U.S. NUCLEAR REGULATORY COMMISSION
REGION IV

Inspection Report: 50-285/93-25

Licensee: Omaha Public Power District
Fort Calhoun Station FC-2-4 Adm.
P.O. Box 399, Hwy. 75 - North of Fort Calhoun
Fort Calhoun, Nebraska

Facility Name: Fort Calhoun Station (FCS)

CEA 31 Rod Control Circuitry Showing Electrical Faults

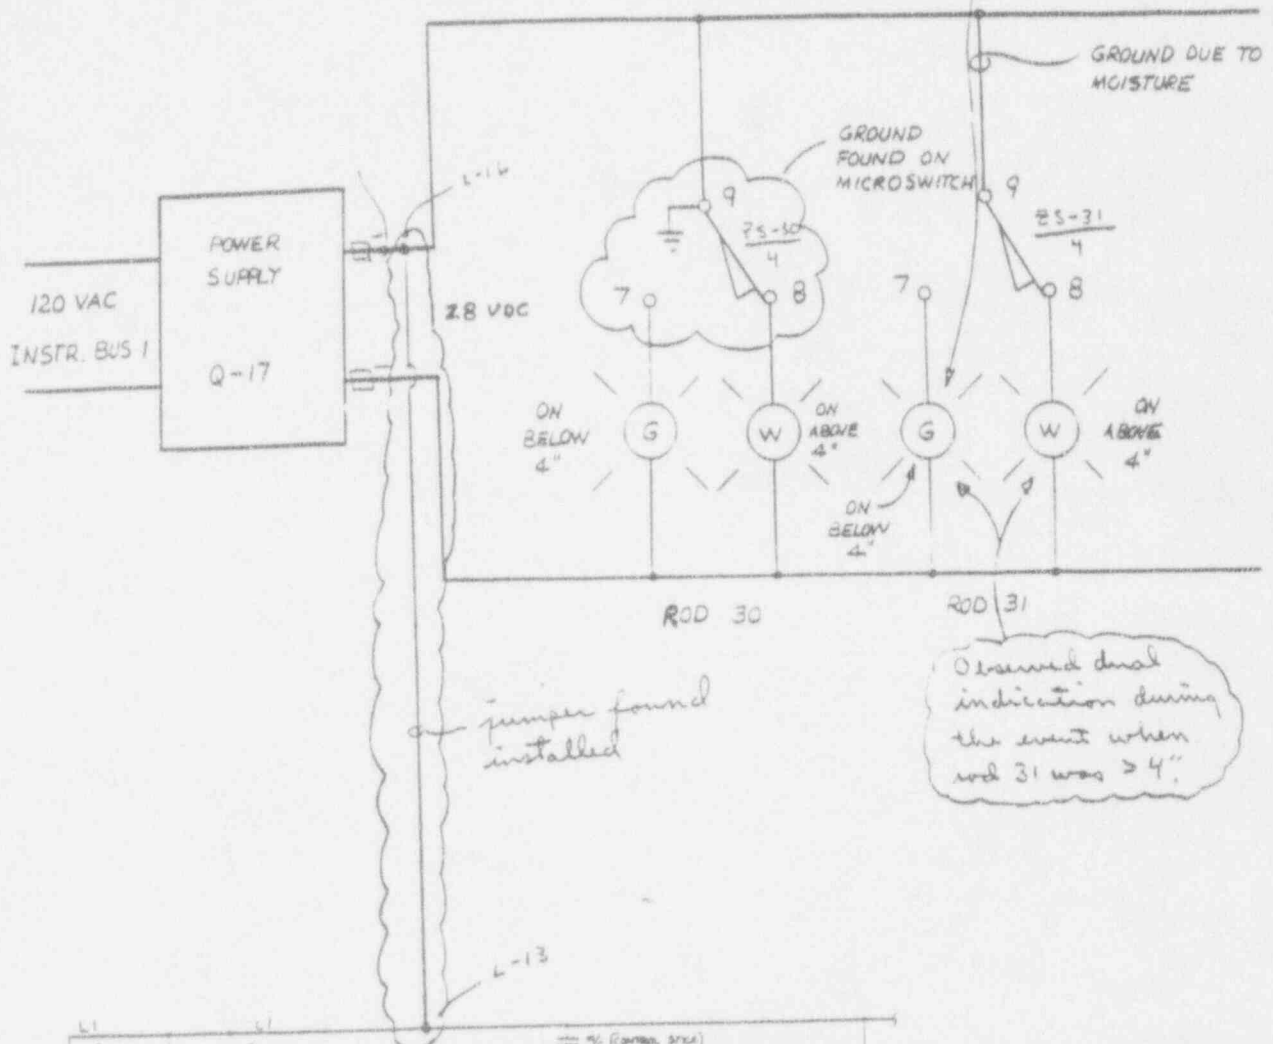
The following electrical faults were identified in the control circuitry that affected the operation of the CEDM for CEA 31 (See Figure 2):

- A jumper wire between the 120 VAC and 28 VDC system. This jumper was installed between terminals L-13 and L-16 located in the main control board. This jumper was apparently installed during plant construction and was shown on plant wiring diagrams. The licensee could not determine the purpose of this jumper and considered it to be a design error. This jumper provided the electrical connection fault that, when combined with the multiple grounds, was needed to cause uncontrolled operation of the CEDM.

- A ground fault, a short, and misadjustment on Limit Switch ZS-31/4 for the CEDM. A microswitch contained within this limit switch was found to be shorted between Terminals 7, 8, and 9 and grounded. The licensee considered the short and grounding to be caused by the presence of a "white" substance within the switch. The licensee speculated that the "white" substance was a boron residue that could have come from wetting the switch. This switch wetting could have been the result of leaks on the reactor head, while coming out of past refueling outages, that sprayed the CEDM. The short caused the abnormal condition of both the green rod bottom light and the white normal operating region light on the core mimic system to be on at the same time. The ground fault provided a path that could cause the CEDM withdrawal contactor coil, RA-31, to be energized.

- A ground fault on Limit Switch ZS-30/4 for the CEDM for CEA 30. The cause for this ground fault could not be determined. This ground fault provided a circuit path that could cause the CEDM withdrawal contactor coil, RA-31, to be energized.

- A ground fault in Limit Switches ZS-31/1 and ZS-31/2 for the CEDM. These limit switches, located in the same vicinity as Limit Switch ZS-31/4, also contained moisture which contributed to the ground fault condition. As discussed for limit switch ZS-31/4, the moisture was probably the result of spraying the CEDM. This ground fault (and the one in the CEDM connector discussed below) provided the other side of the circuit path that was needed to keep coil RA-31 energized.

- A ground fault in the connector for the CEDM. This connector contained moisture and was in the same vicinity as the CEDM limit switches. Again, this moisture was probably the result of spraying the CEDM. Personnel that worked near the reactor vessel head during the refueling outage were interviewed and the source of the moisture could not be definitely determined.

- Troubleshoot, identify, and eliminate all grounds in the rod control, core mimic, and rod block systems. Remove the hardwired connection between the 120 VAC and 28 VDC power supplies.
- Install a permanent ground detection system on the rod control and core mimic systems.
- Perform comprehensive testing of the rod control, core mimic, and rod block systems.
